# LiDAR Quality Assessment Report

MD-NRCS-LiDAR

# USGS NRCS Maryland LiDAR Project

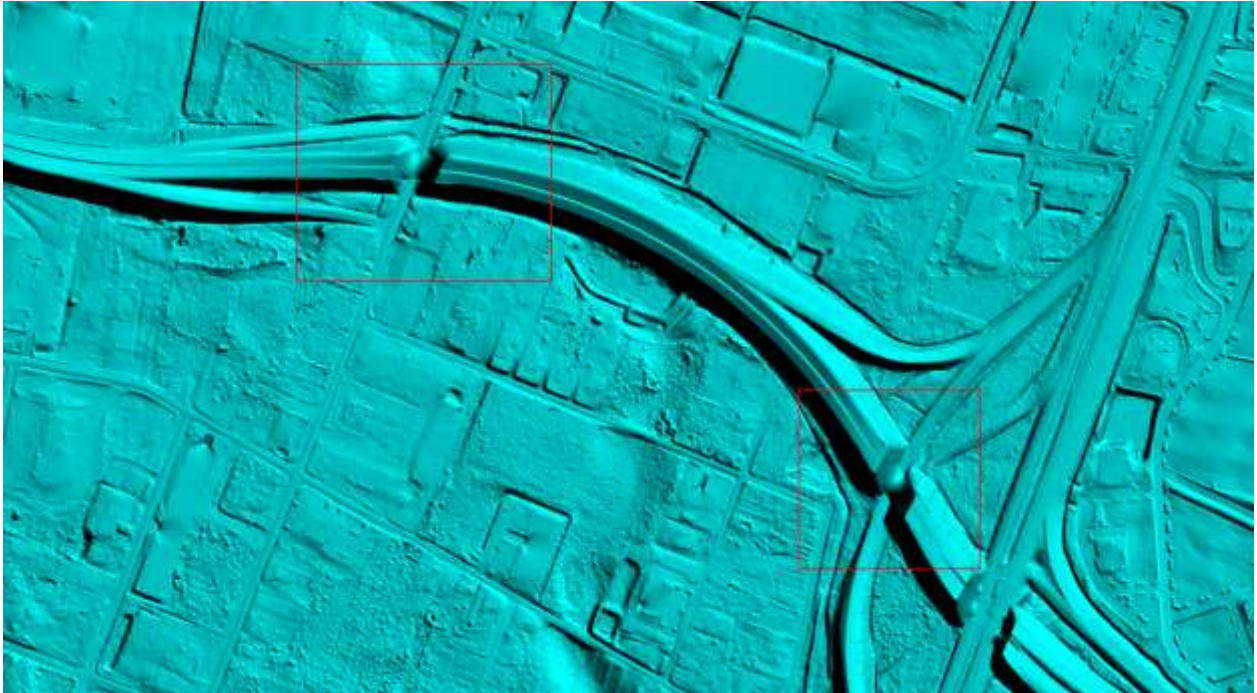
bridge saddles located @ 38° 24' 4.8618" N, 75° 34' 31.2381" W  
NOT ADDRESSED. see vendors notes in Dewberry's response to NGTOC calls

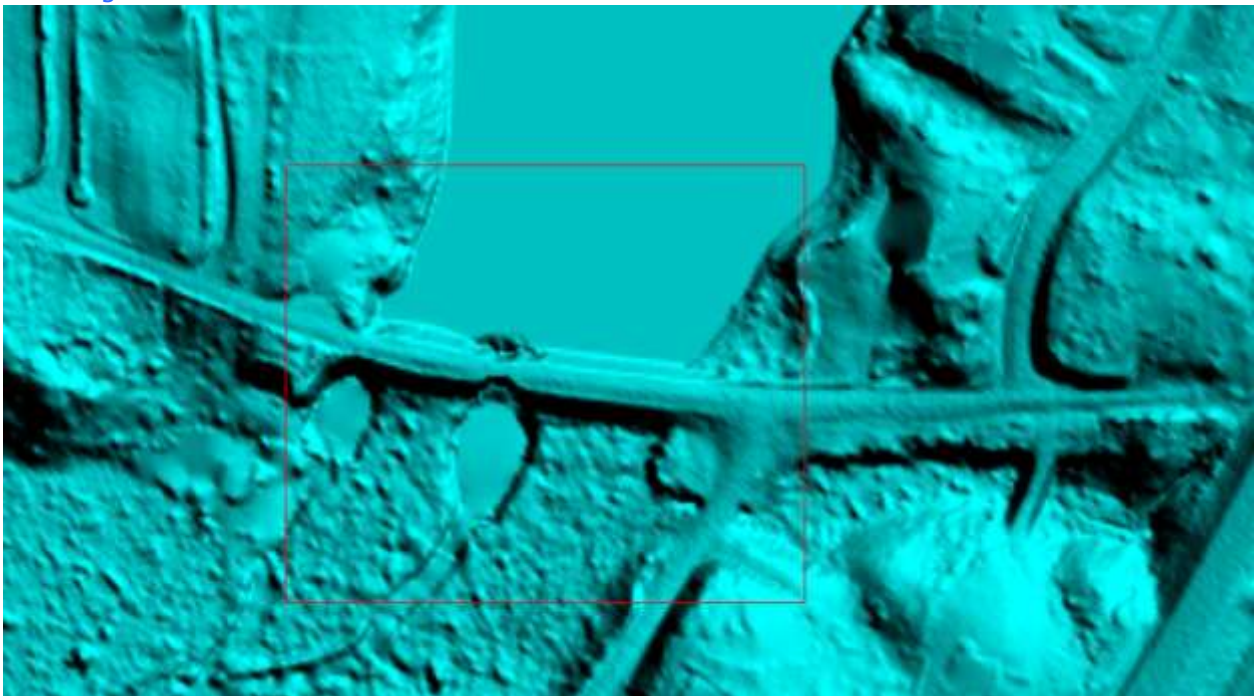
remove bridge over spillway @ 38° 20' 44.4756" N, 75° 32' 50.0916" W  
CORRECTED

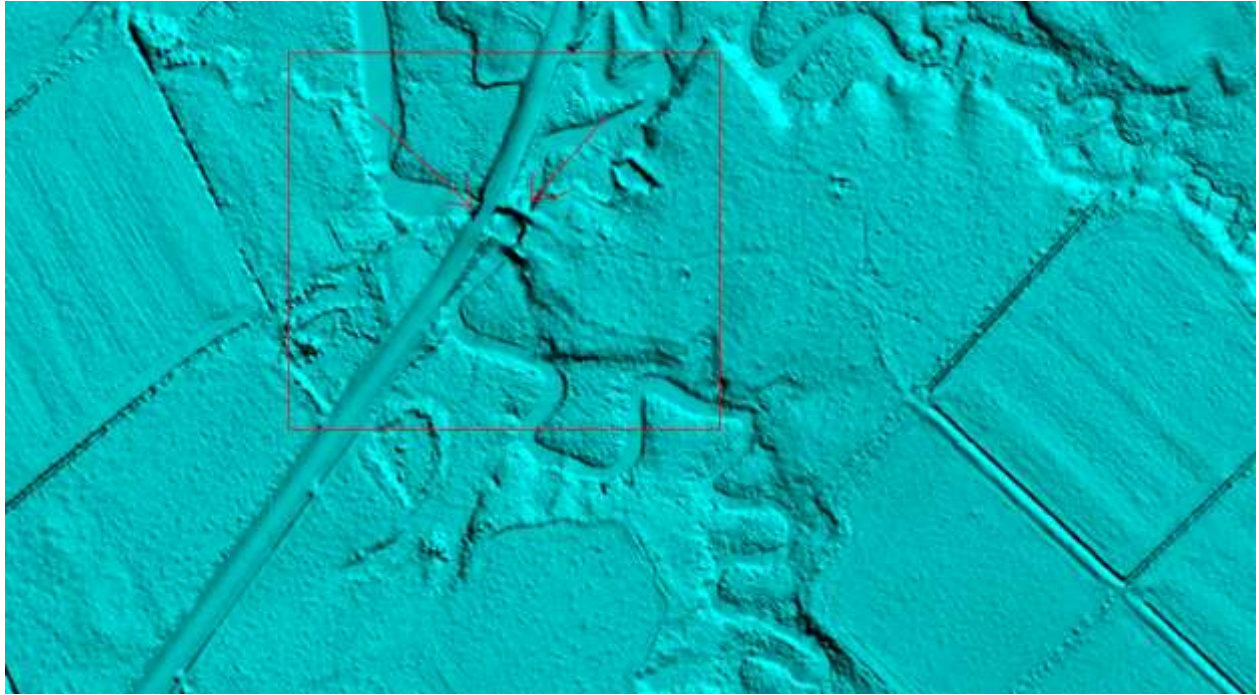
remove 2 bridges located @ 38° 19' 15.2754" N, 75° 48' 59.5812" W  
CORRECTED

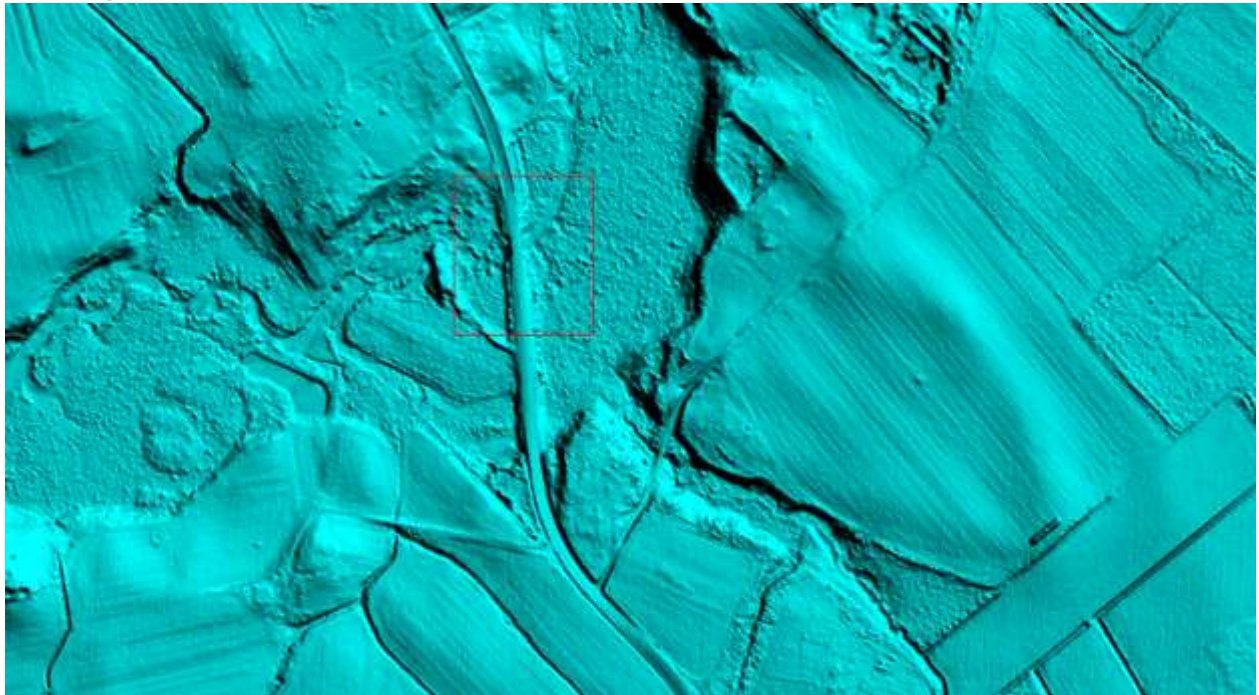
remove bridge located @ 38° 22' 12.0200" N, 75° 44' 21.1144" W  
CORRECTED

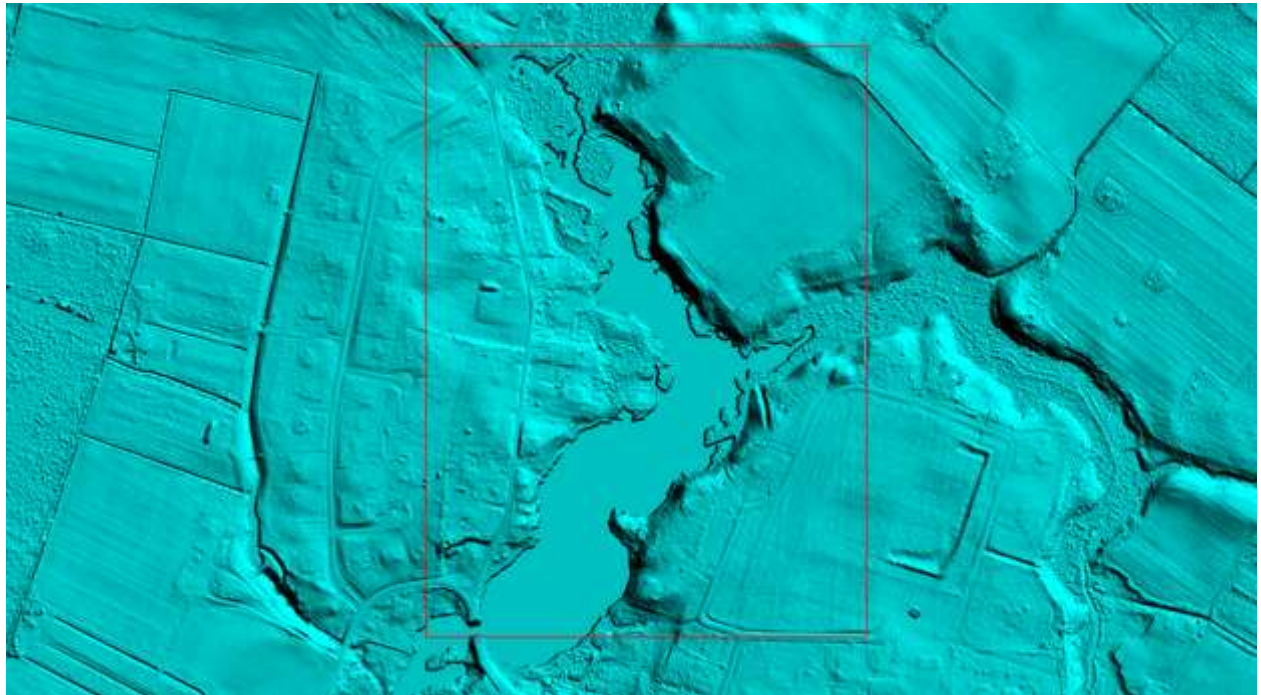
breaklines on lake are too deep located @  $38^{\circ} 17' 9.8247''$  N,  $75^{\circ} 41' 9.1096''$  W  
CORRECTED

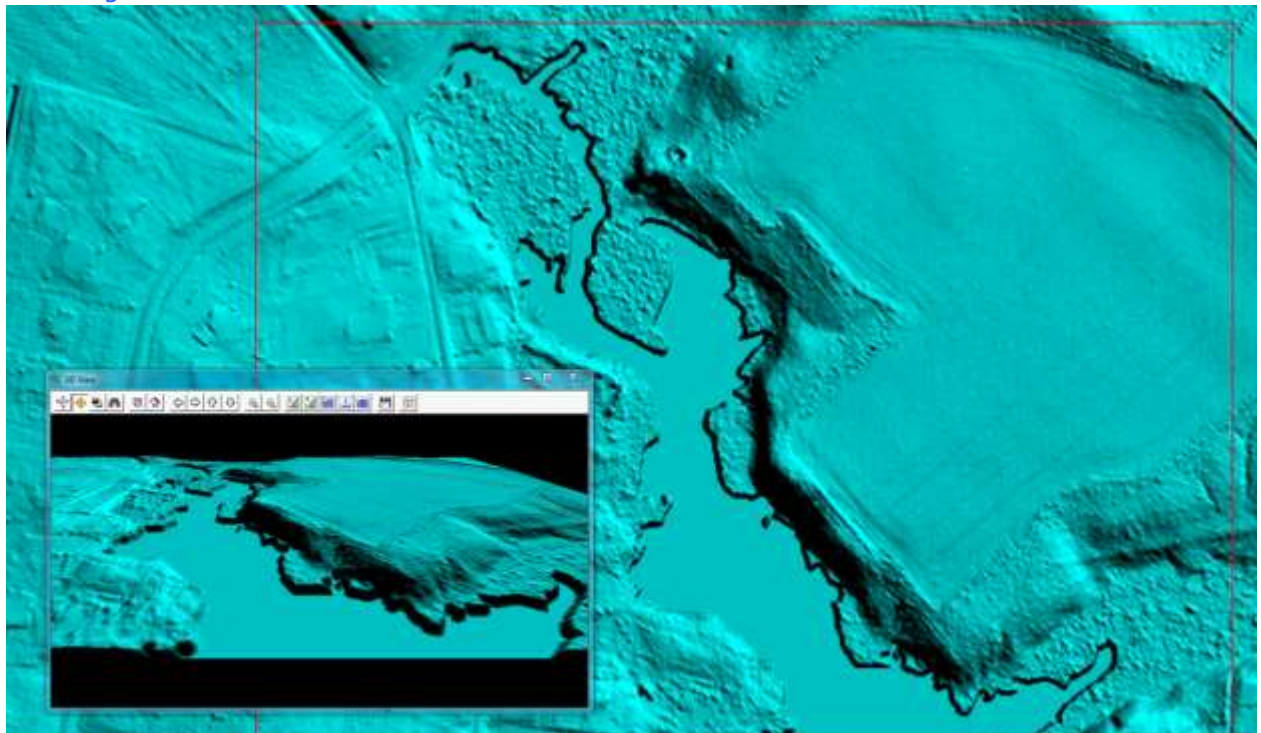
breaklines too deep 3-D  
CORRECTED

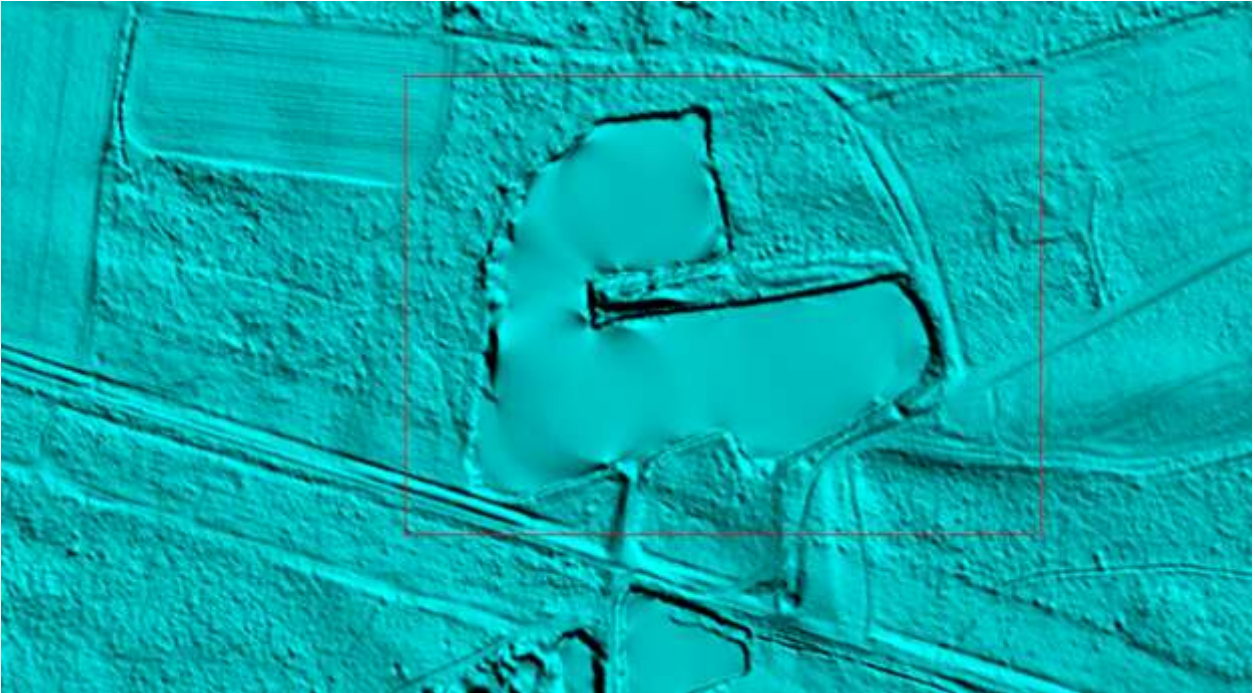
water to be flattened @  $38^{\circ} 28' 14.2357''$  N,  $75^{\circ} 47' 7.1275''$  W  
CORRECTED

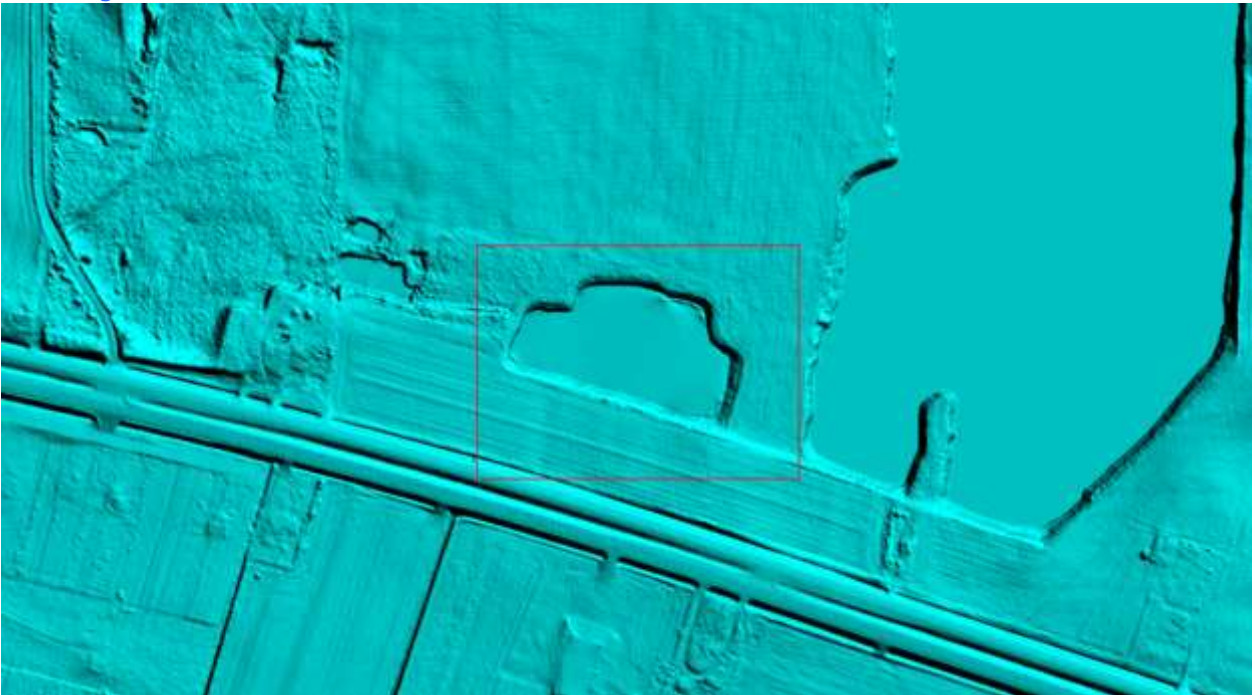
water to be flattened @  $38^{\circ} 27' 19.8438''$  N,  $75^{\circ} 42' 58.2044''$  W  
CORRECTED

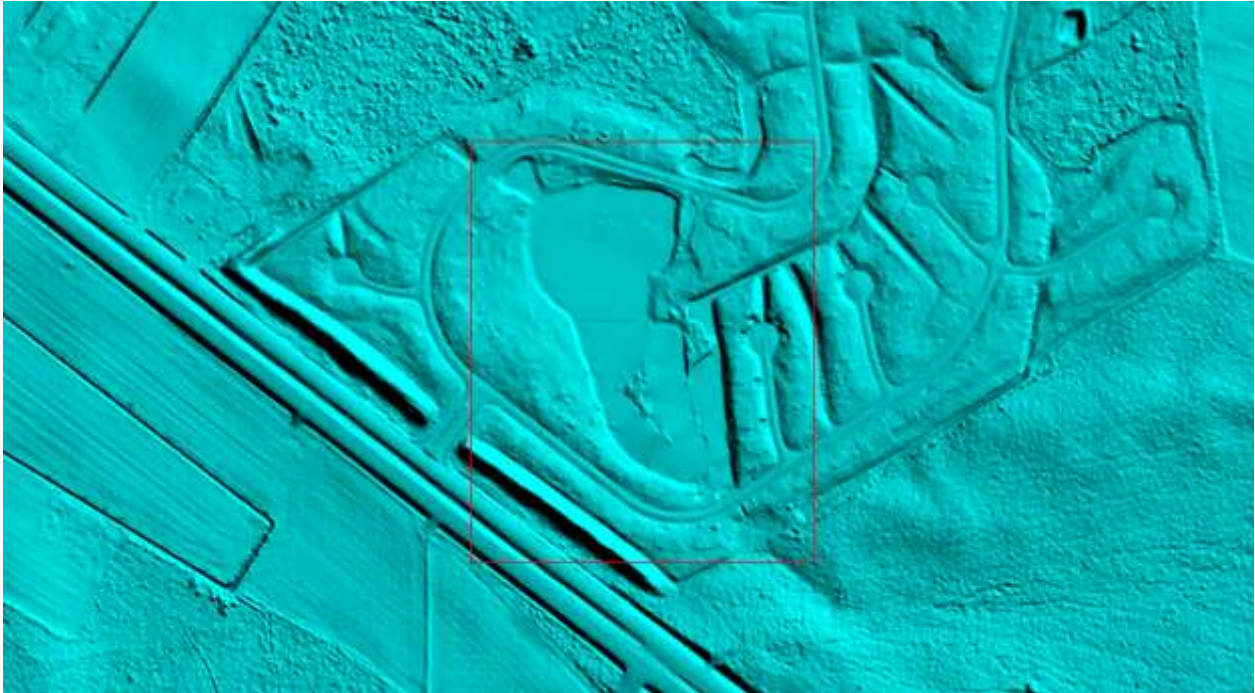
water to be flattened @ 38° 26' 33.5163" N, 75° 41' 15.1955" W  
CORRECTED

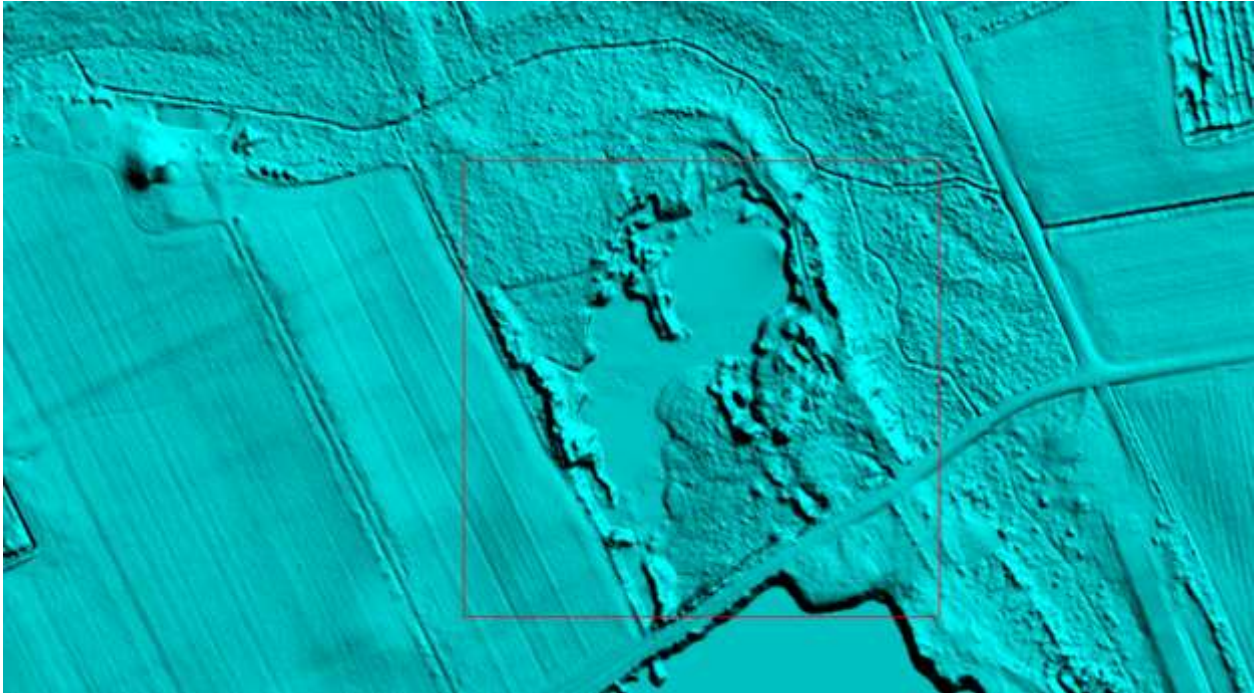
water to be flattened @ 38° 24' 56.7589" N, 75° 43' 25.4398" W  
CORRECTED

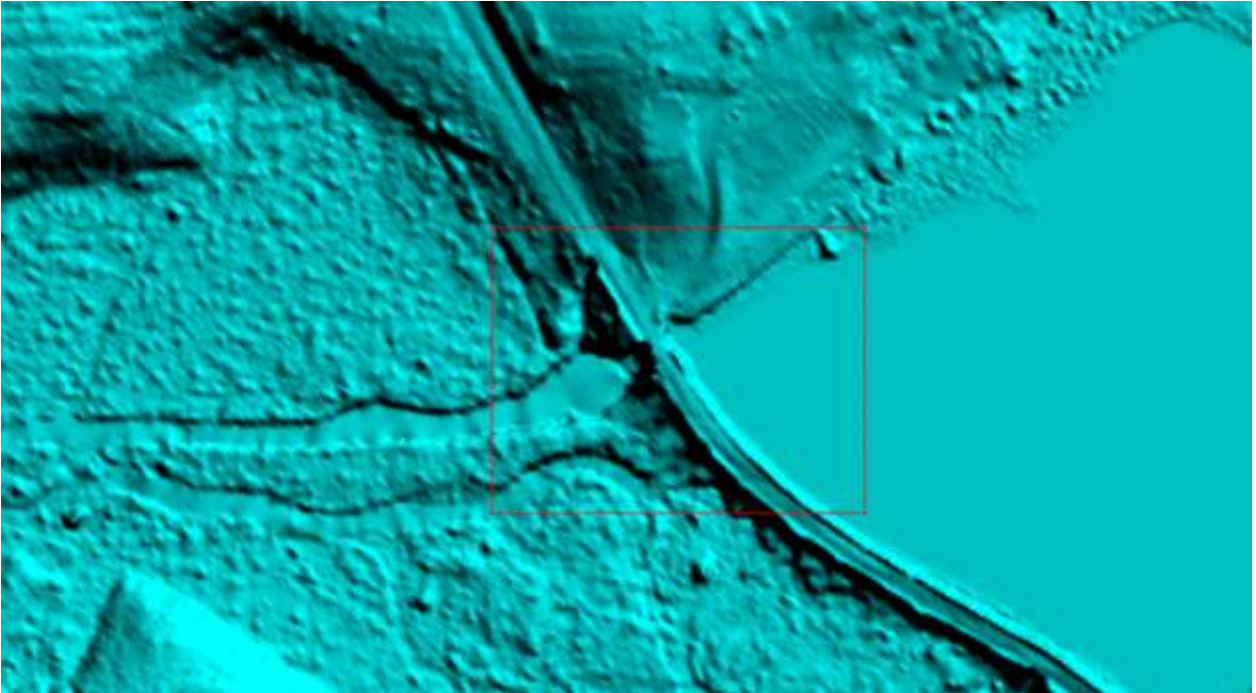
replace roadbank at culvert @ 38° 27' 43.9171" N, 75° 44' 5.8522" W  
CORRECTED

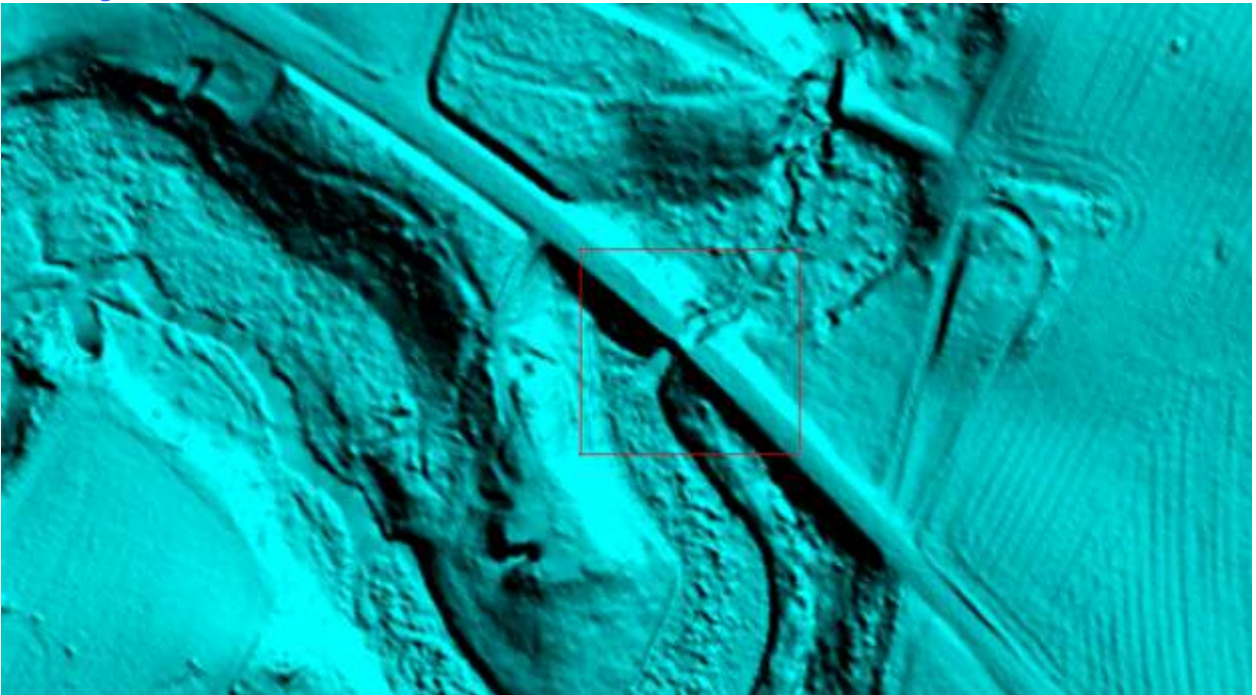
replace culvert @ 38° 27' 49.7043" N, 75° 42' 26.9051" W  
NOT ADDRESSED. see vendors notes in Dewberry's response to NGTOC calls
